JOPLIN PUBLIC SAFETY TRAINING FACILITY
JOPLIN, MISSOURI

ARCHITECT'S PROJECT 13061.000

ADDENDUM 1

Wednesday, March 3, 2016

SITE PLAN

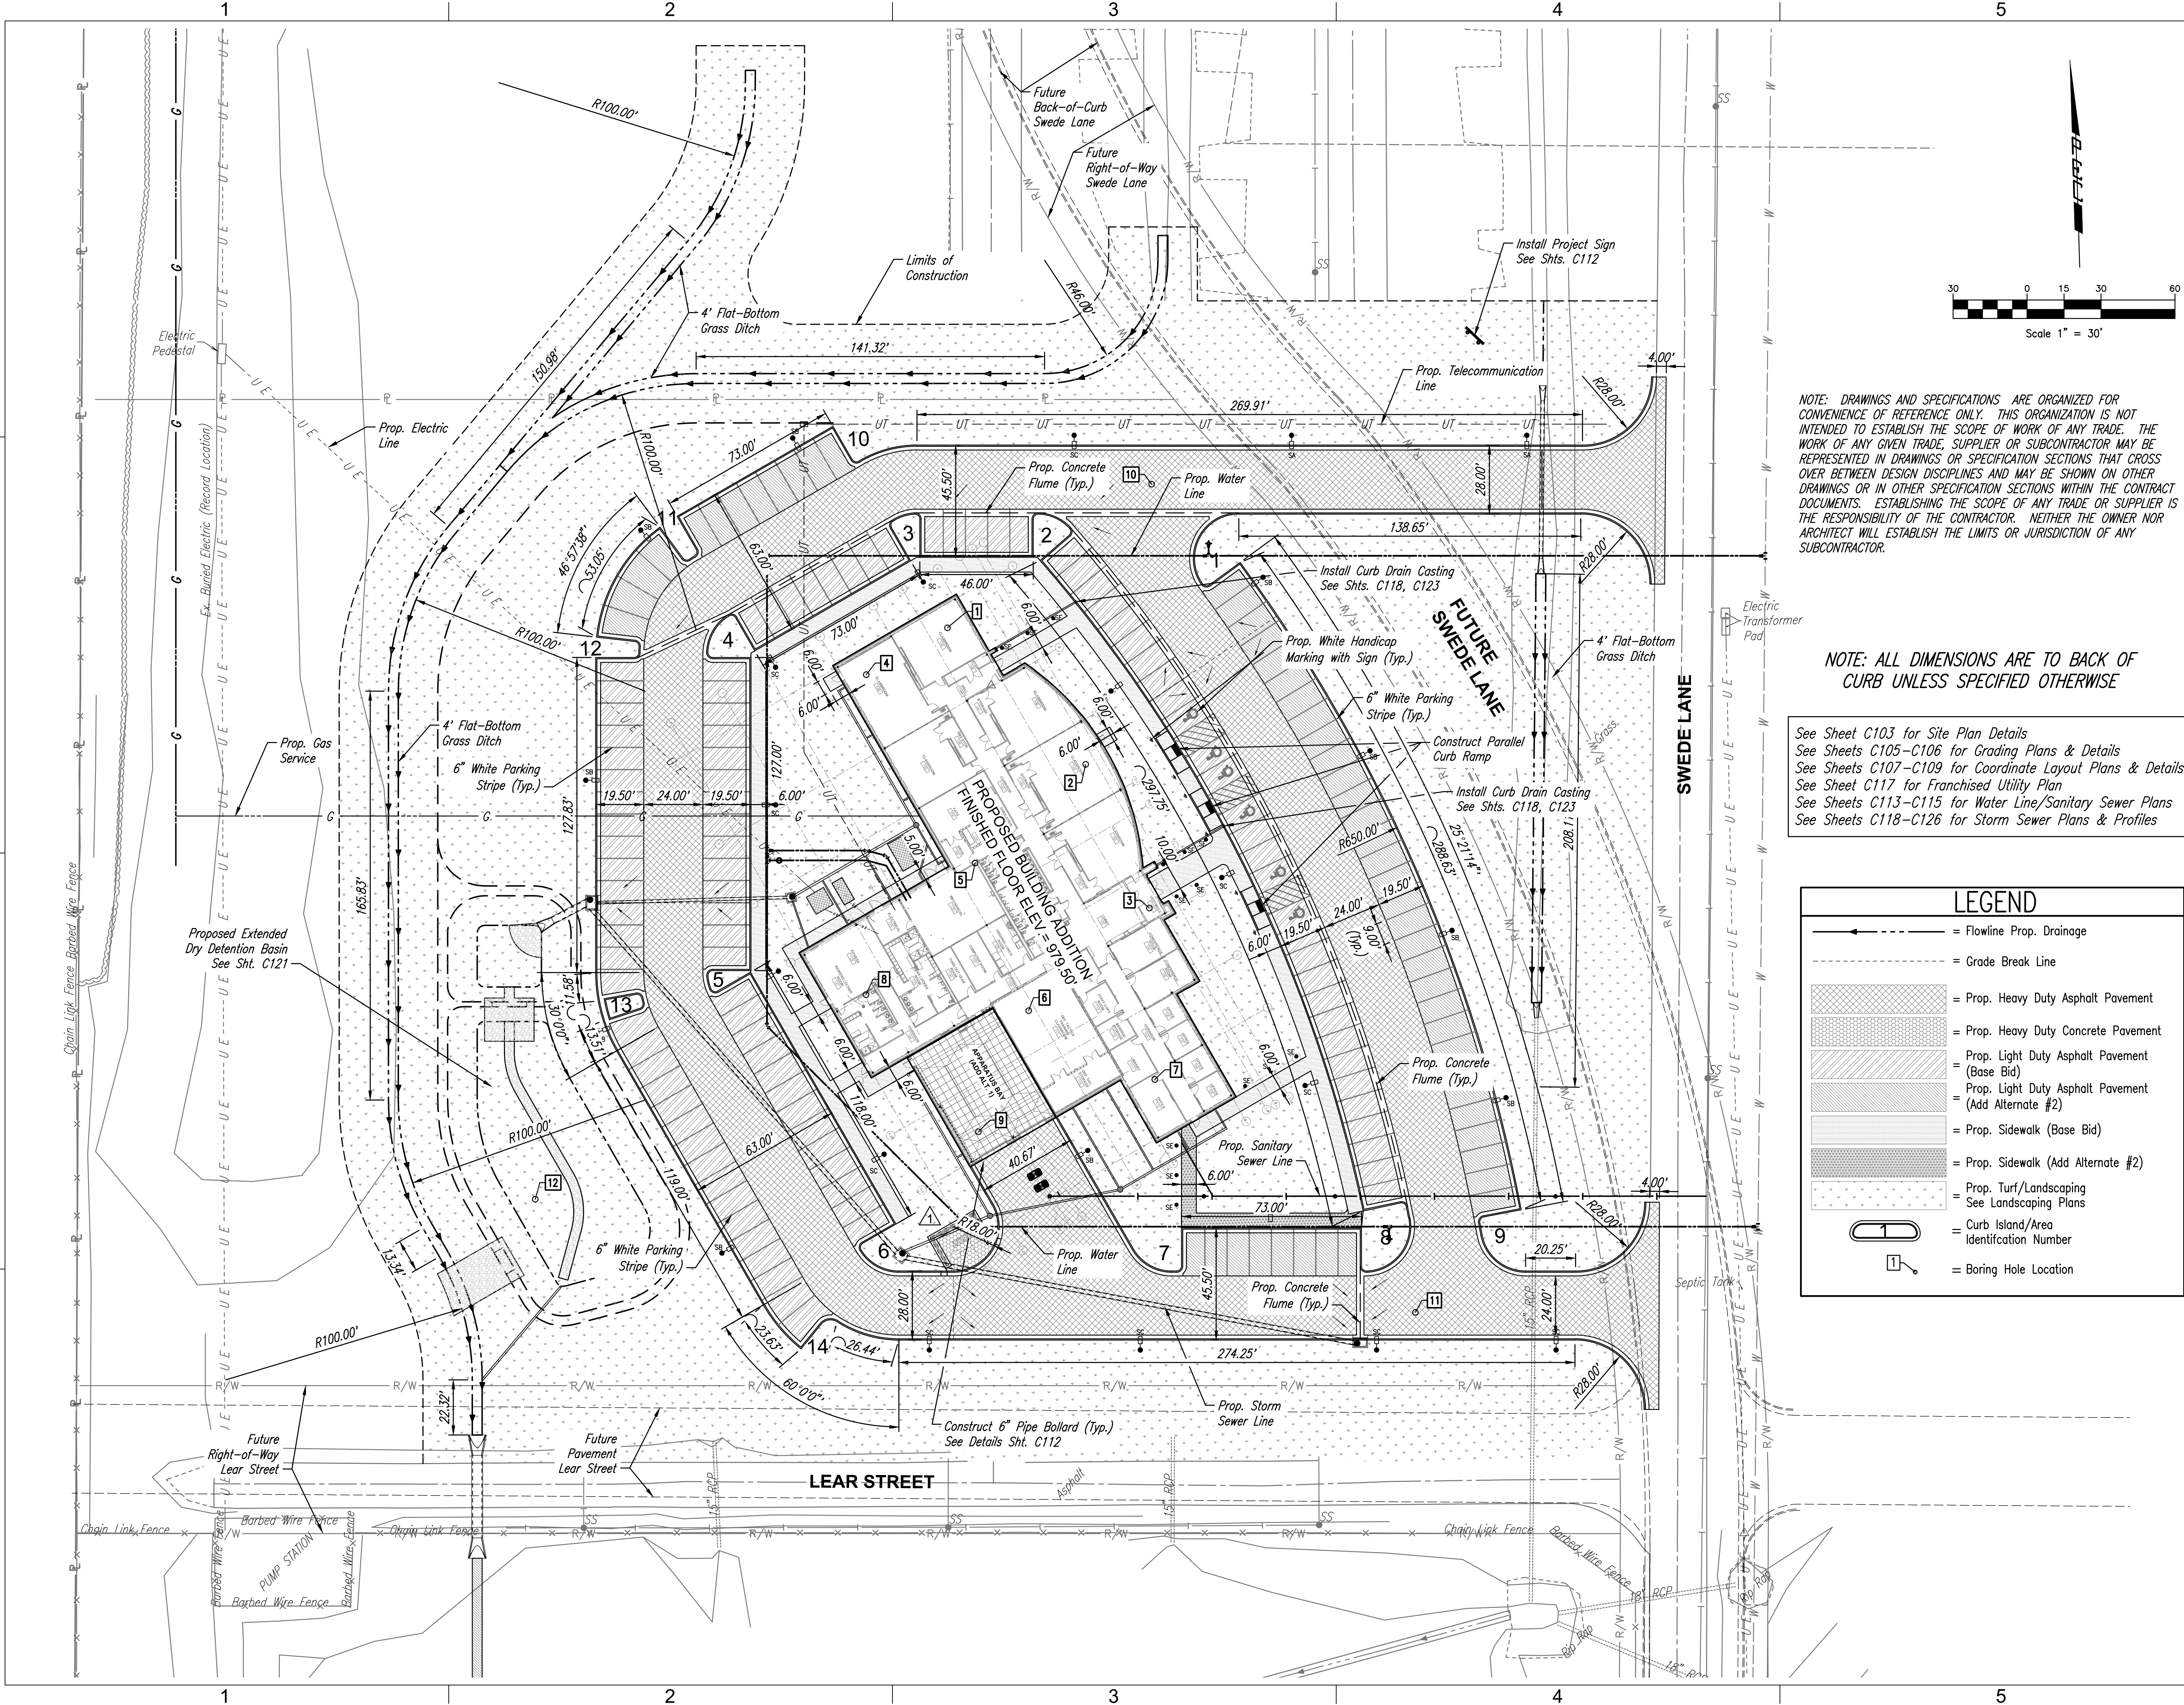
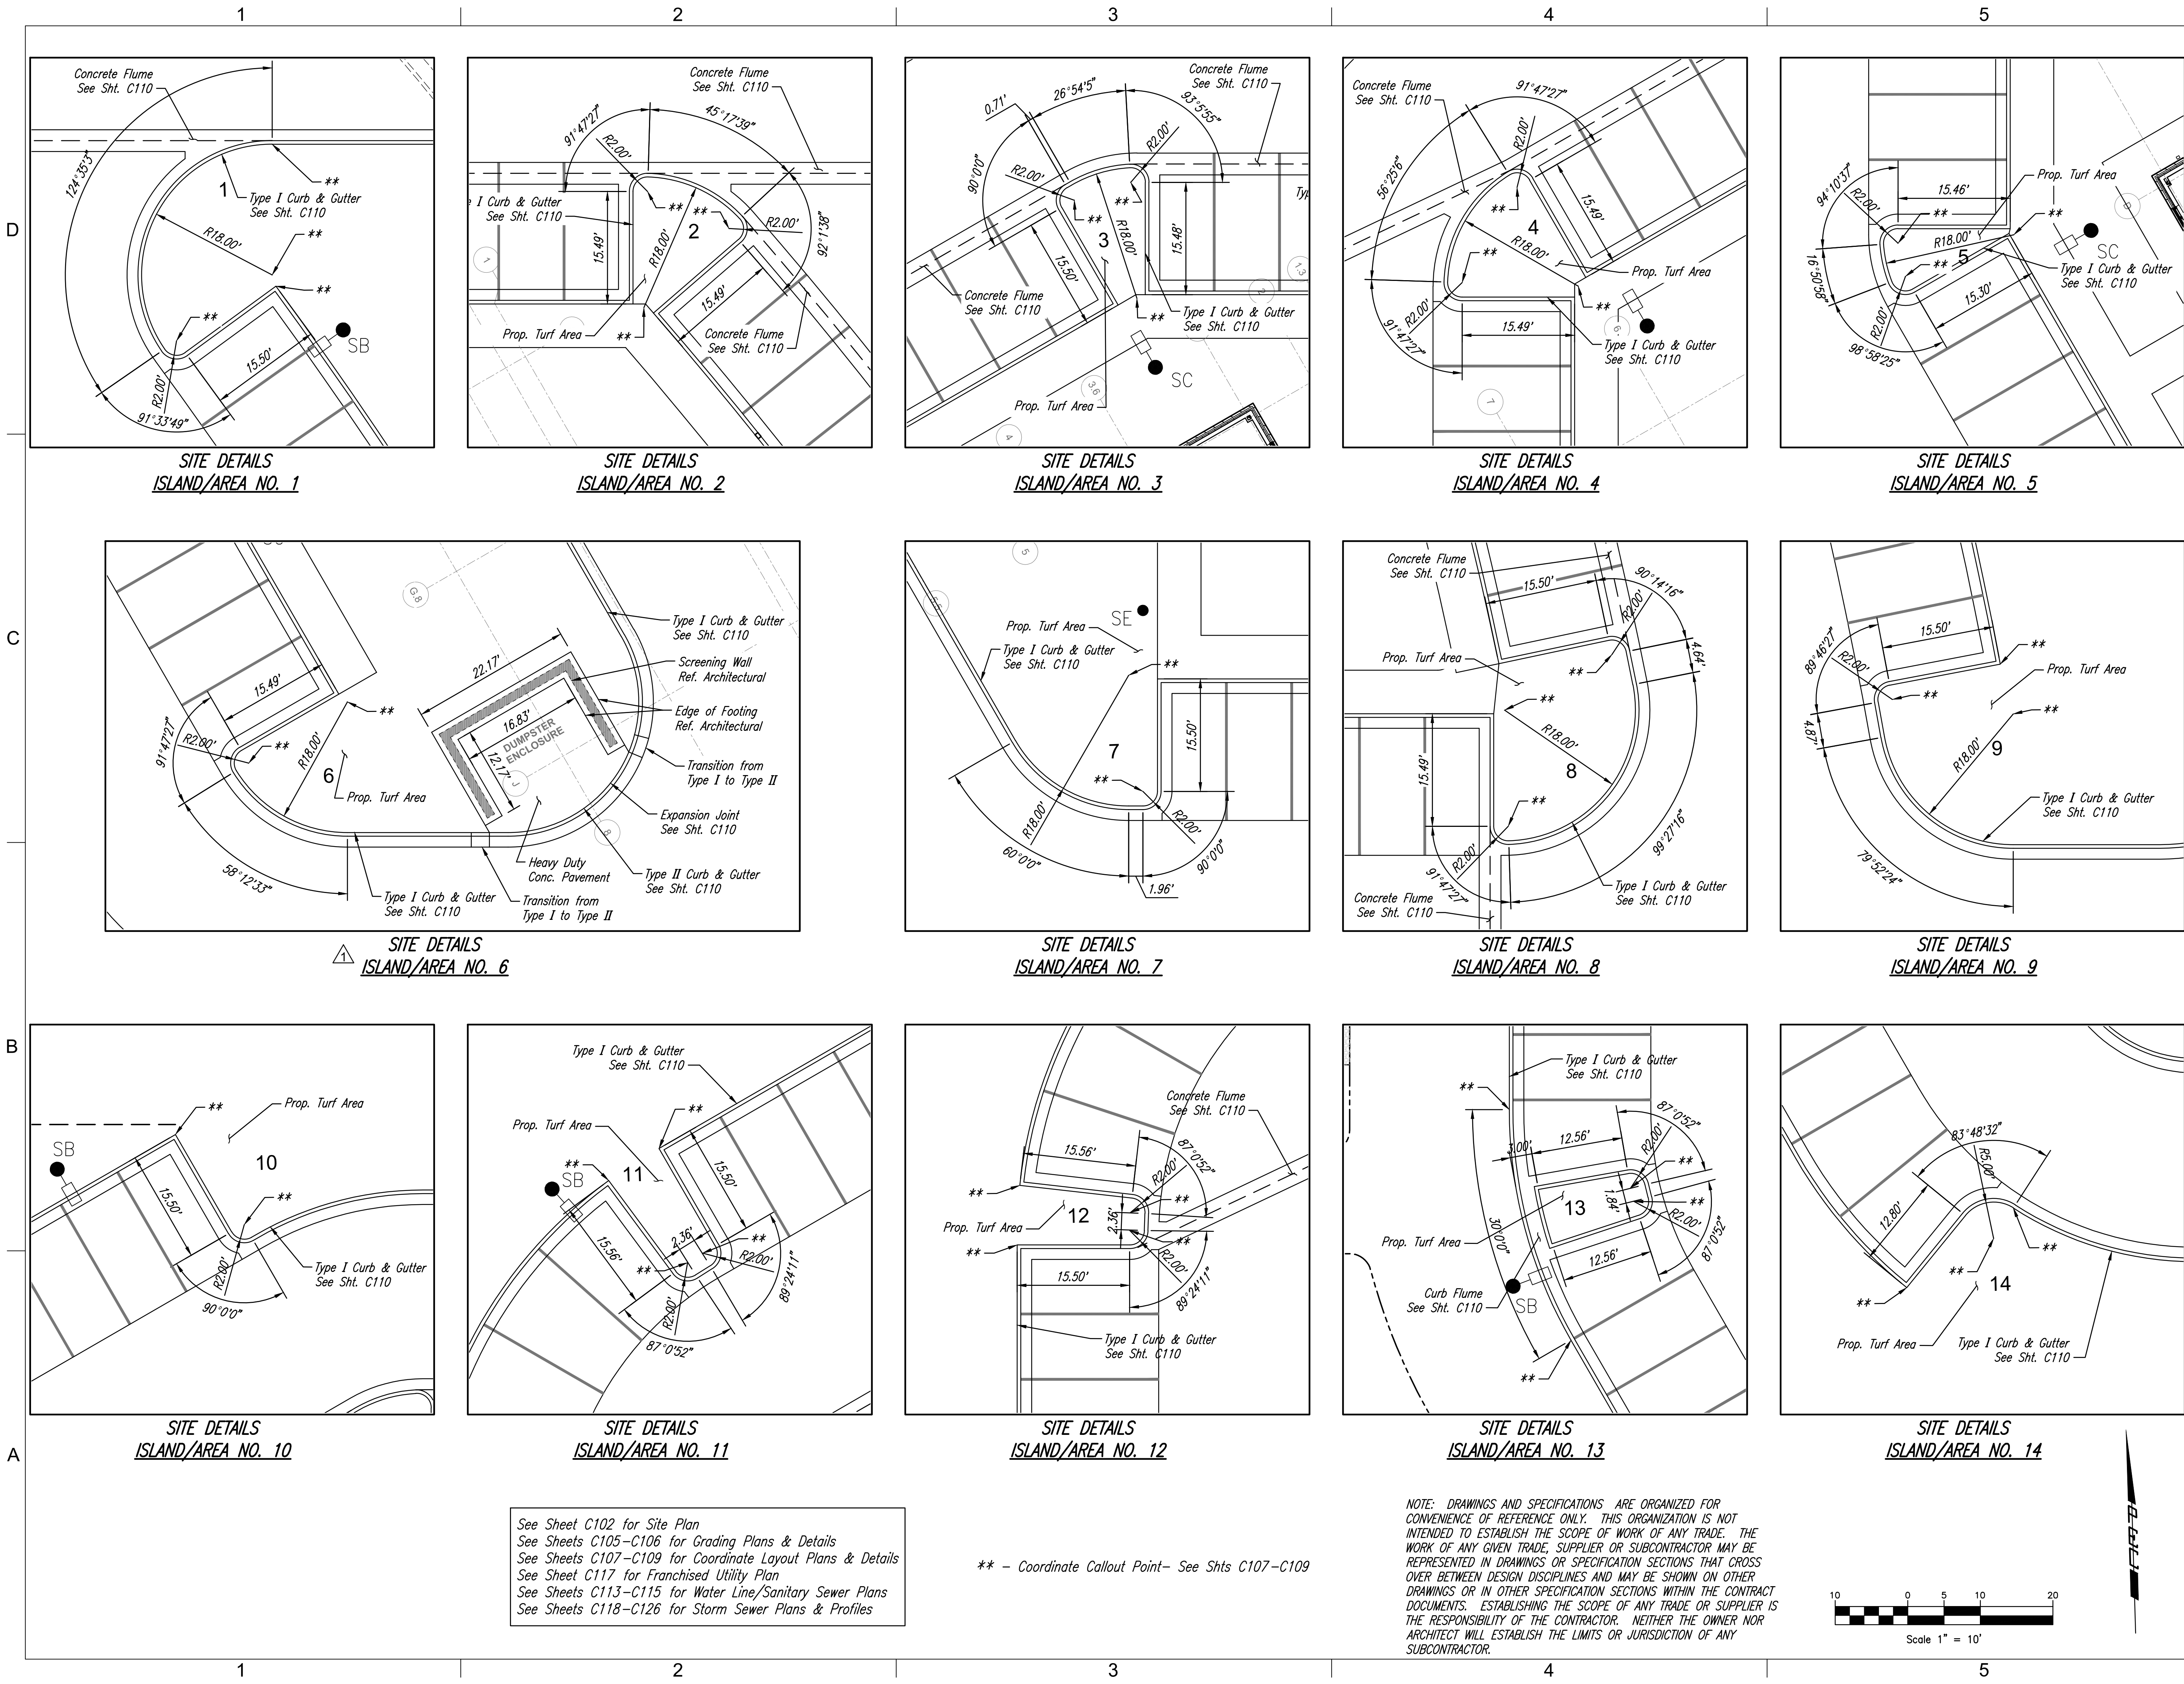
ADD 1-7 SHEET C102 – SITE PLAN: Replace the existing Sheet C102 in its entirety with the attached Sheet C102, revision date March 2, 2016. This Sheet reflects revisions to the dumpster enclosure.

SITE PLAN DETAILS

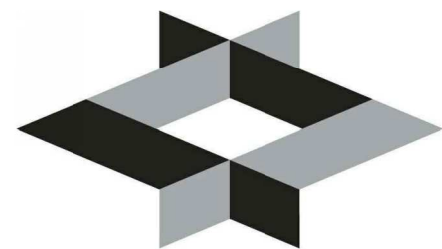
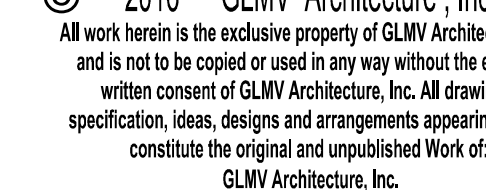
ADD 1-8 SHEET C103 – SITE PLAN DETAILS: Replace the existing Sheet C103 in its entirety with the attached Sheet C103, revision date March 2, 2016. Island/Area 6 reflects revisions to the dumpster enclosure.

C105

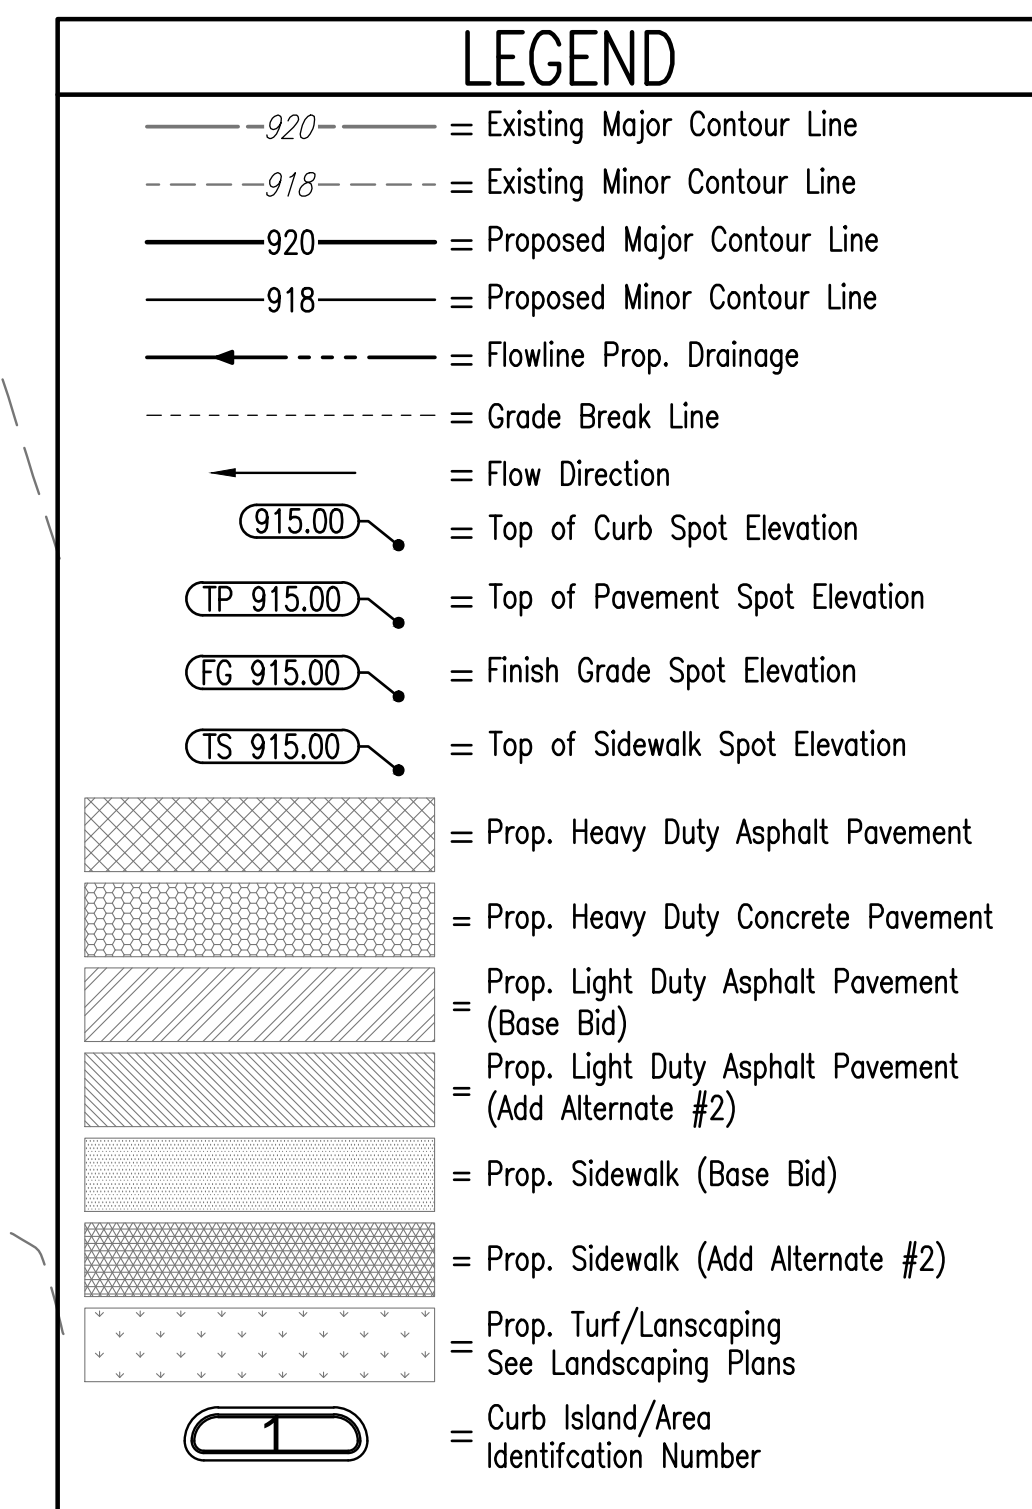
ADD 1-9 SHEET C105 – GRADING PLAN: Replace the existing Sheet C105 in its entirety with the attached Sheet C105, revision date March 2, 2016. This Sheet reflects revisions to the dumpster enclosure.
